PROJECT: ADDENDUM NO.: 1

Willow Lake School Addition

OWNER: DATE OF ISSUANCE: Willow Lake School District 12-3 February 10, 2023

CO-OP Architecture

A101A

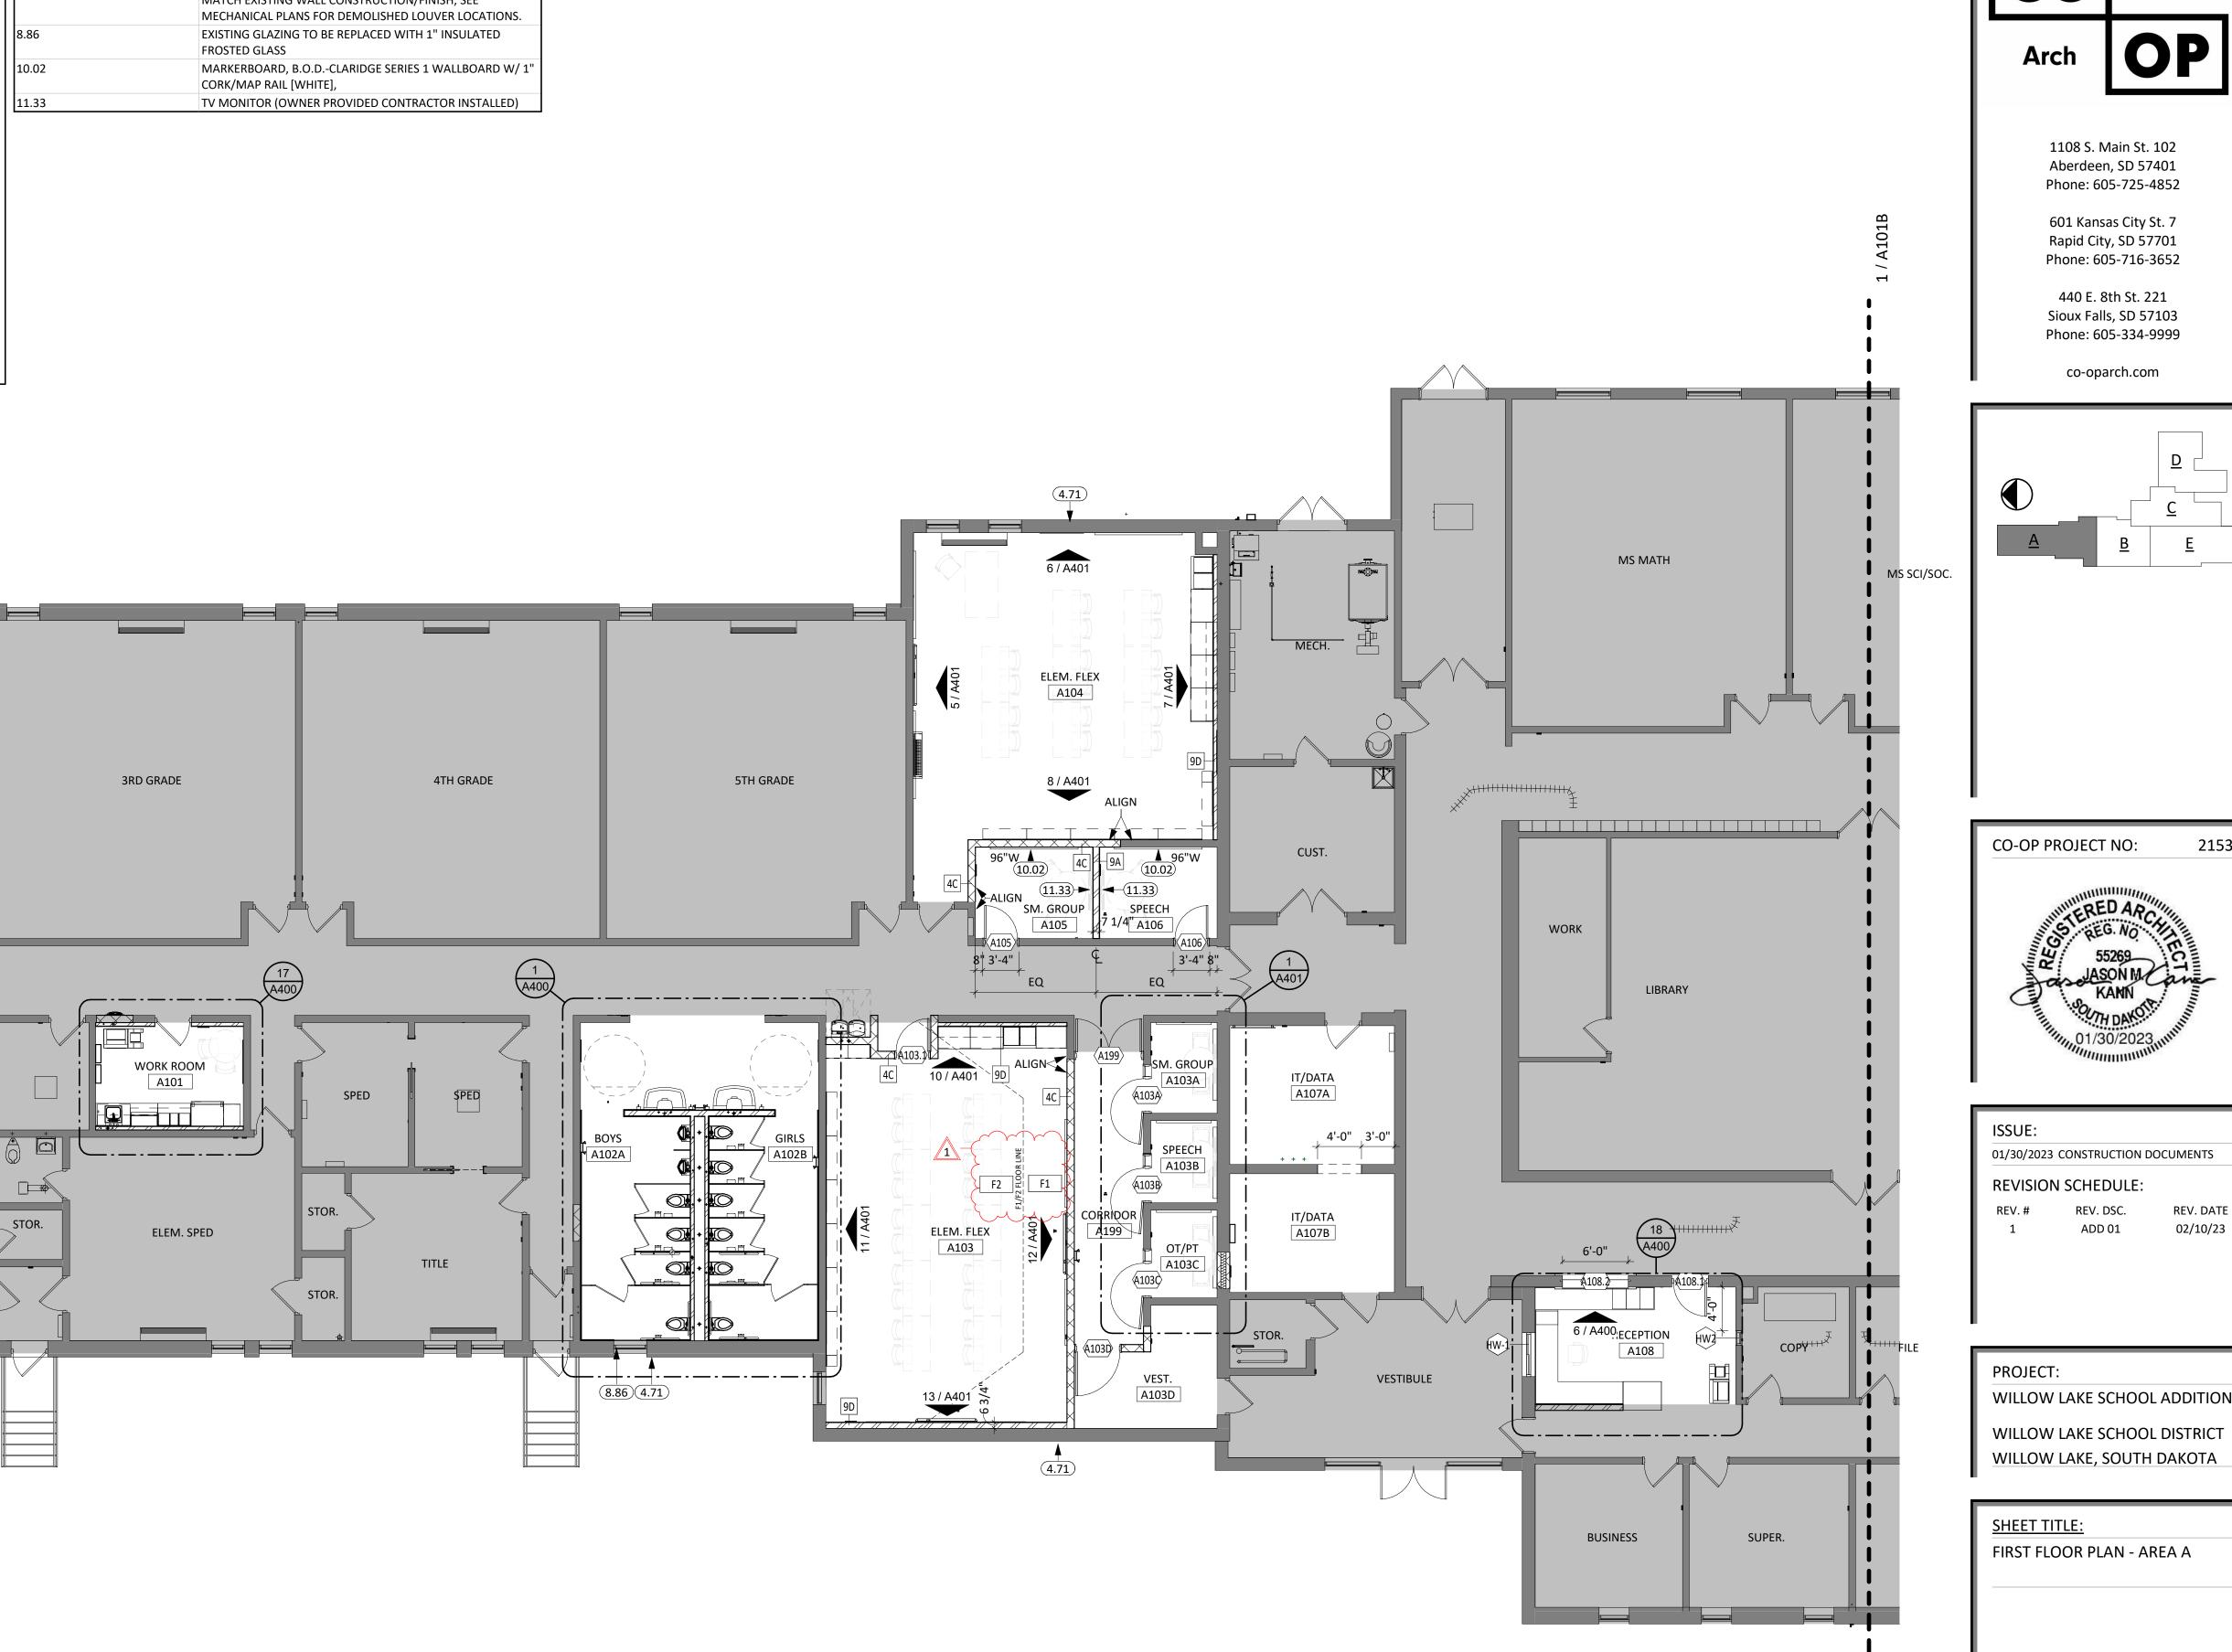
- 9) Sheet A101A FIRST FLOOR PLAN AREA 'A'
 - a. Clarified location of floor type 'F2'.
- 10) Sheet A101C FIRST FLOOR PLAN AREA 'C'
 - a. Clarified locations of wall access panels.

FIRST FLOOR PLAN - AREA D

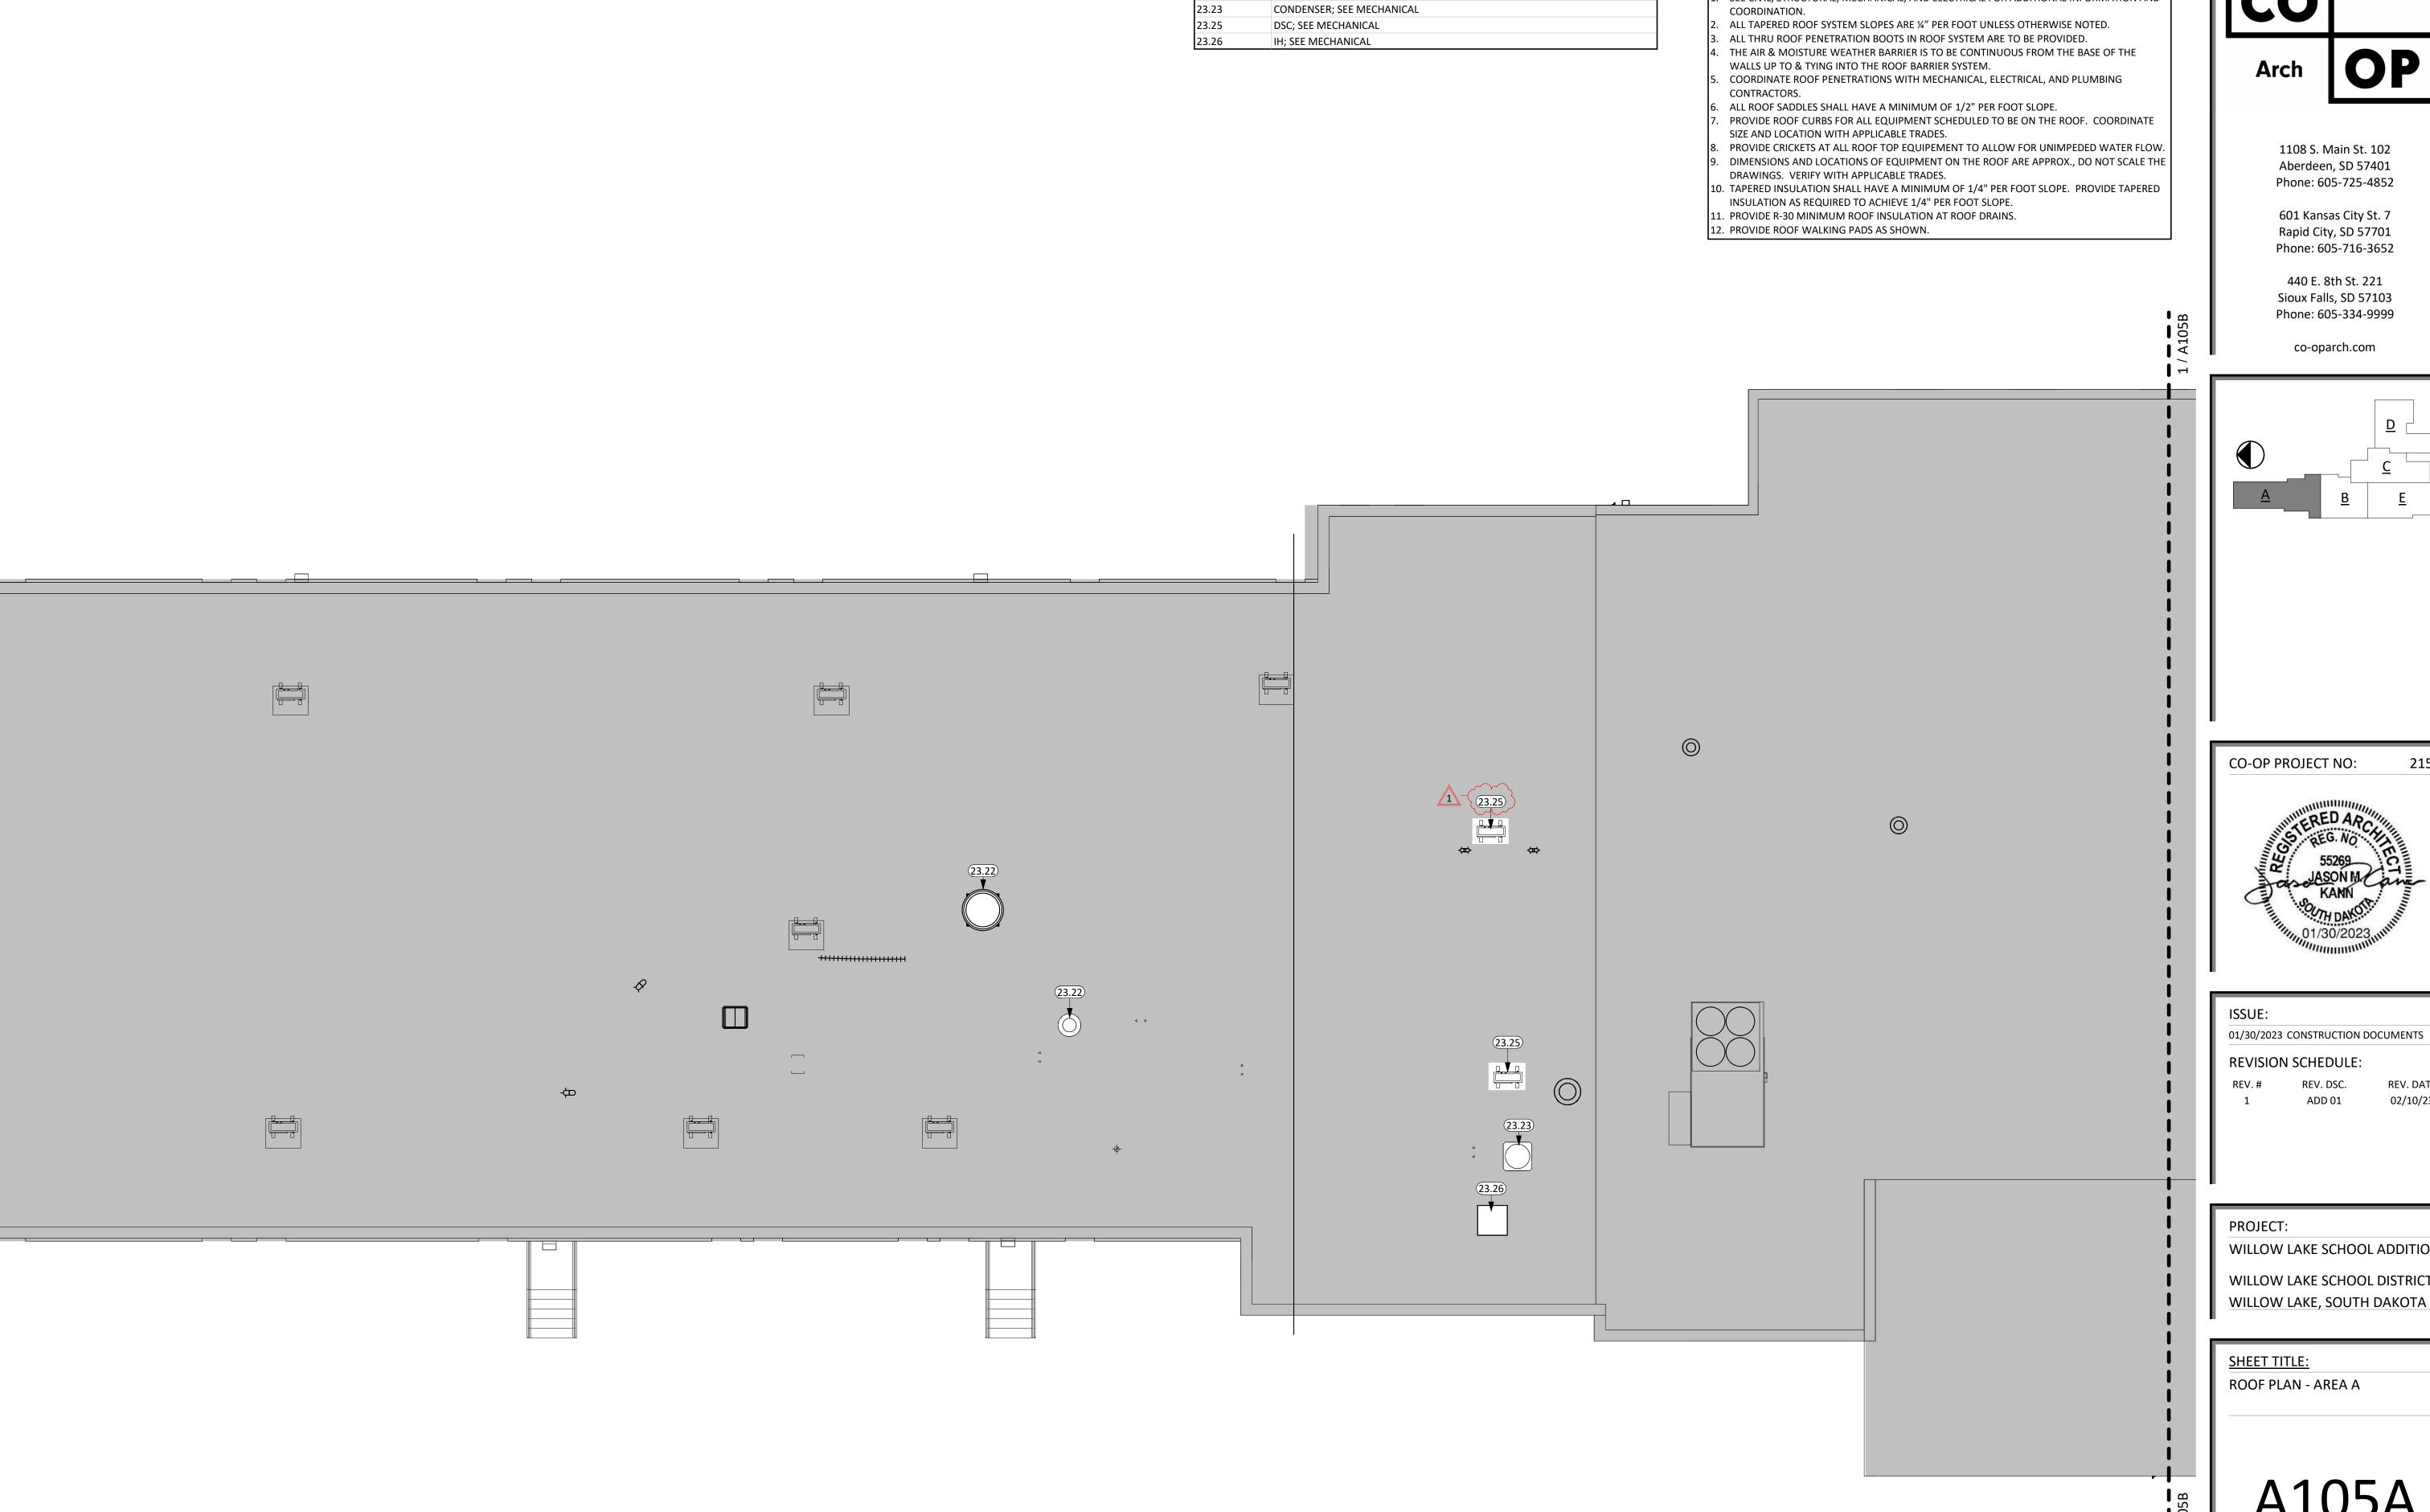
- 11) Sheet A101D FIRST FLOOR PLAN AREA 'D'
 - a. Revised countertop keynote in TOOLS D103C.
 - b. Added 'F5' floor tag for clarity.
- 12) Sheet A105A ROOF PLAN AREA 'A'

A105A

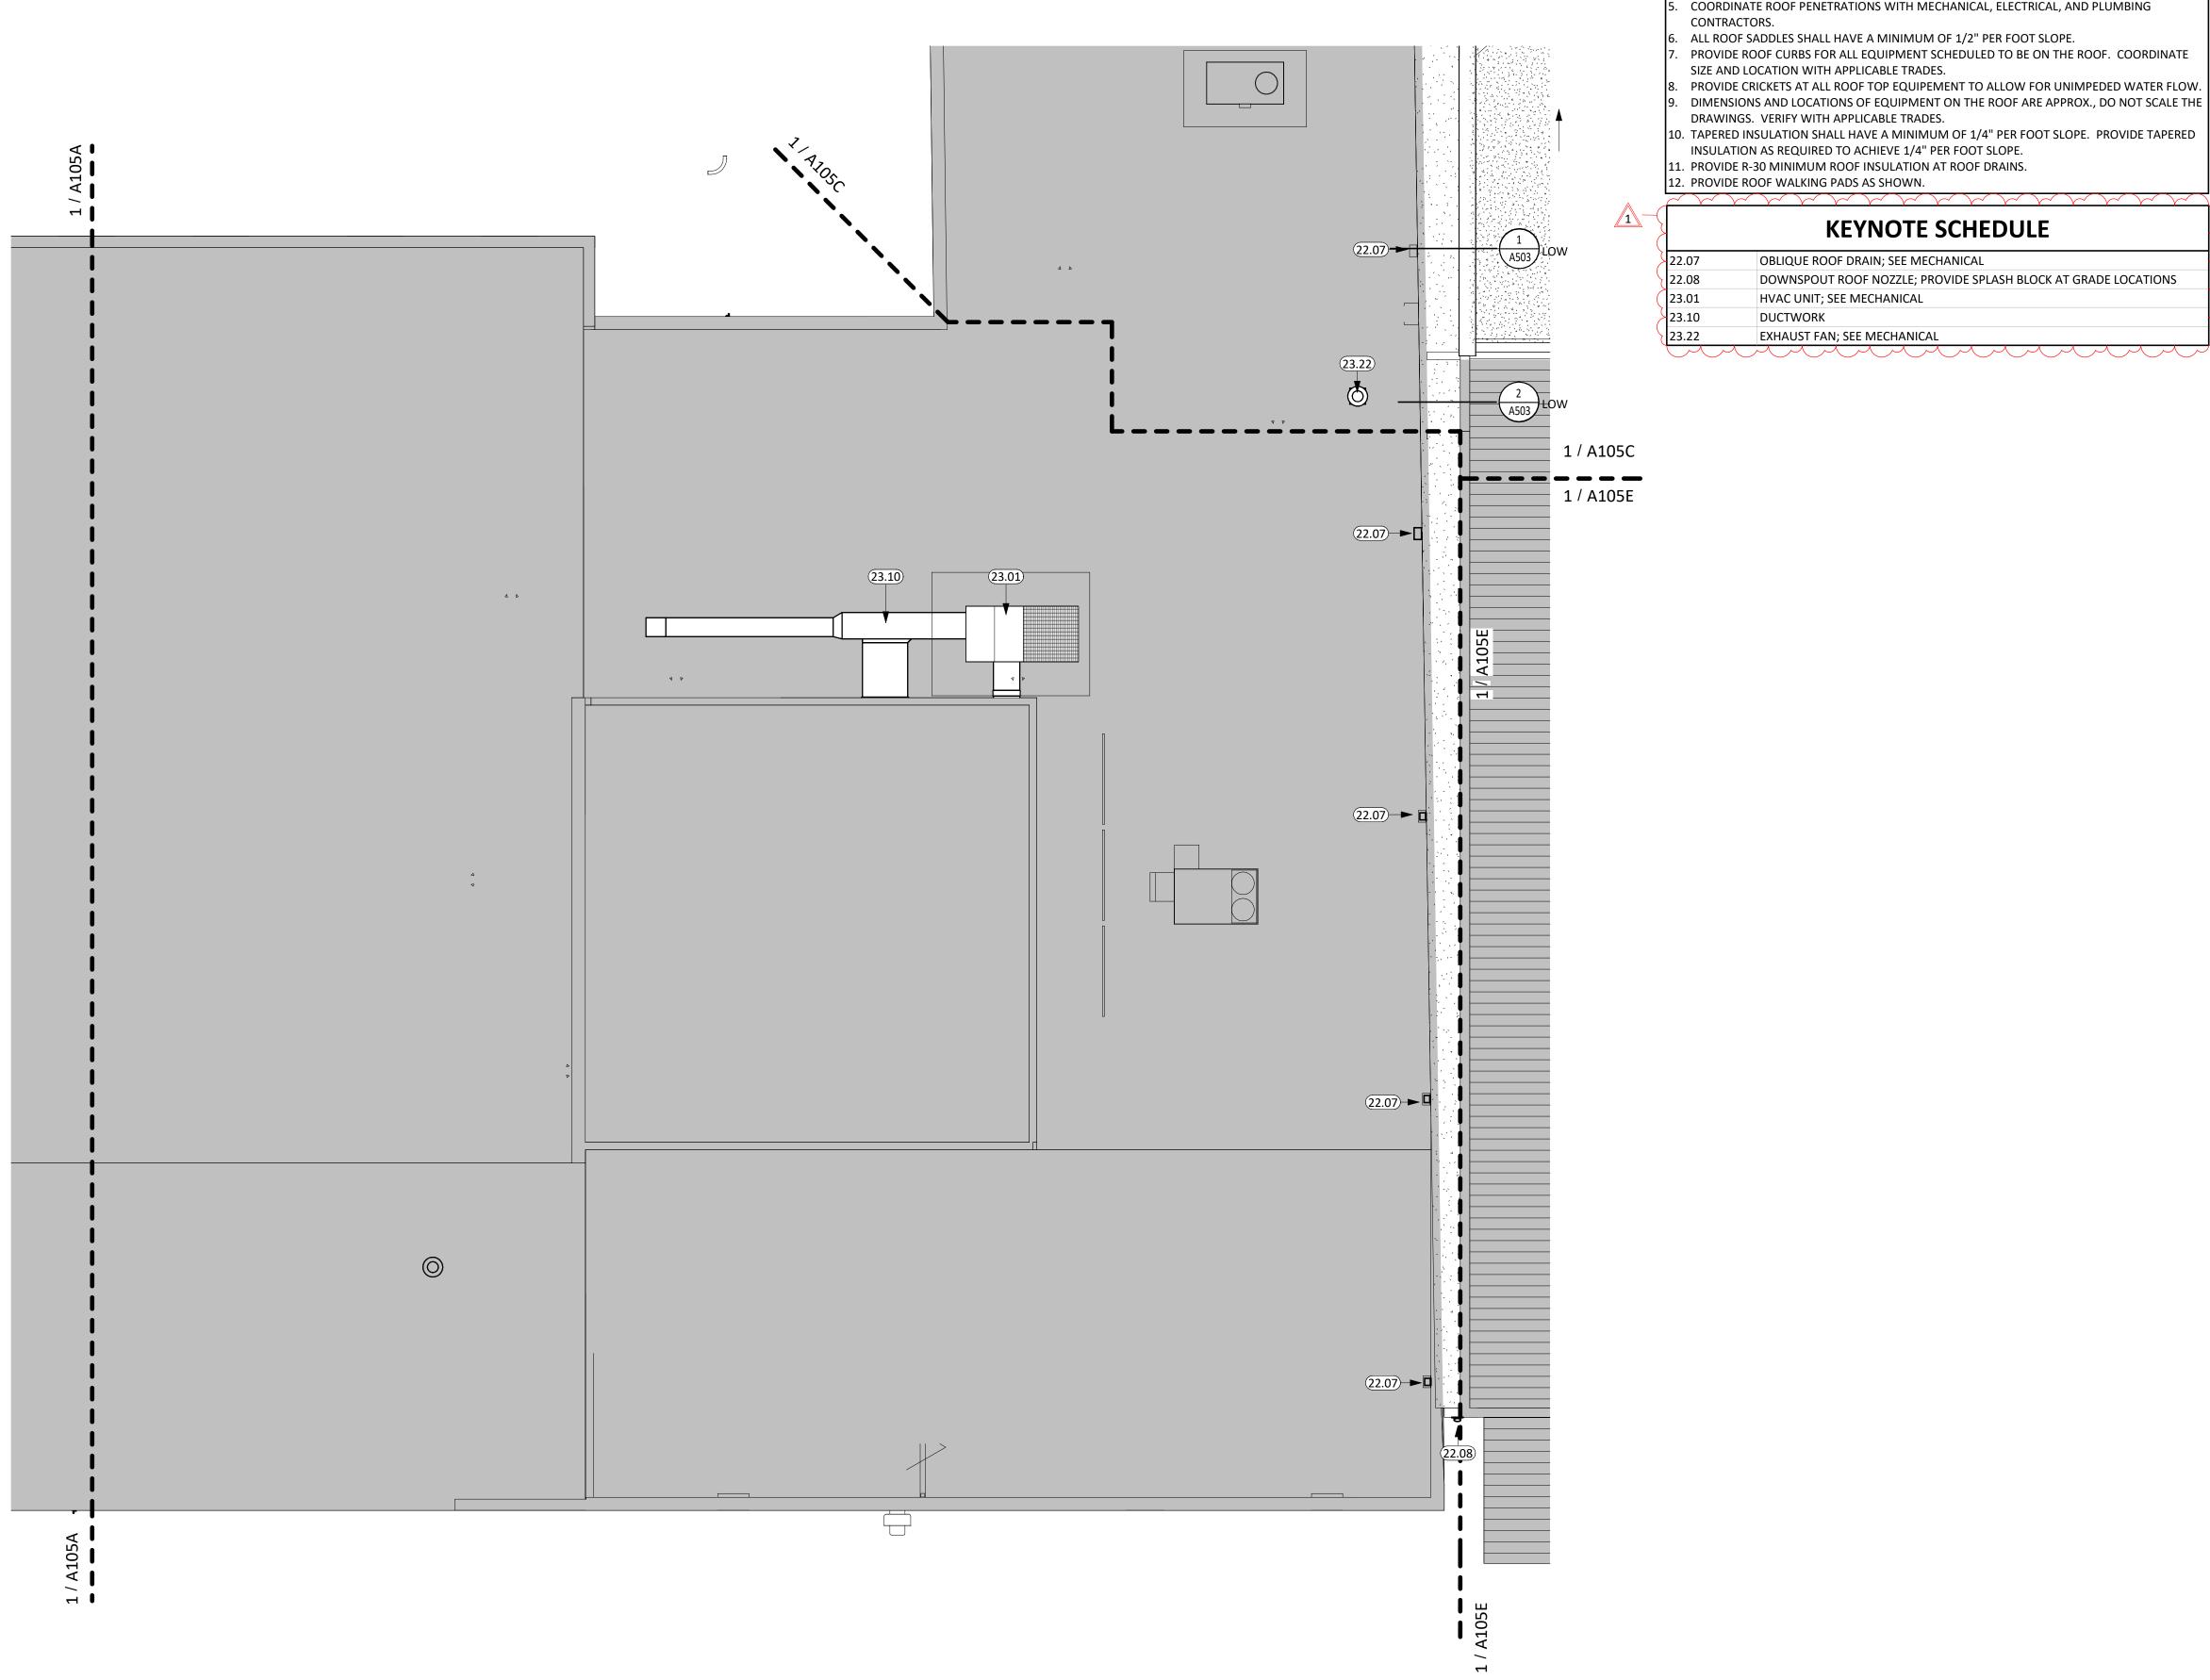
- a. Added keynote for clarification.
- 13) Sheet A105B ROOF PLAN AREA 'B'
 - a. Updated keynote schedule to show missing keynotes.
- 14) Sheet A105C ROOF PLAN AREA 'C'
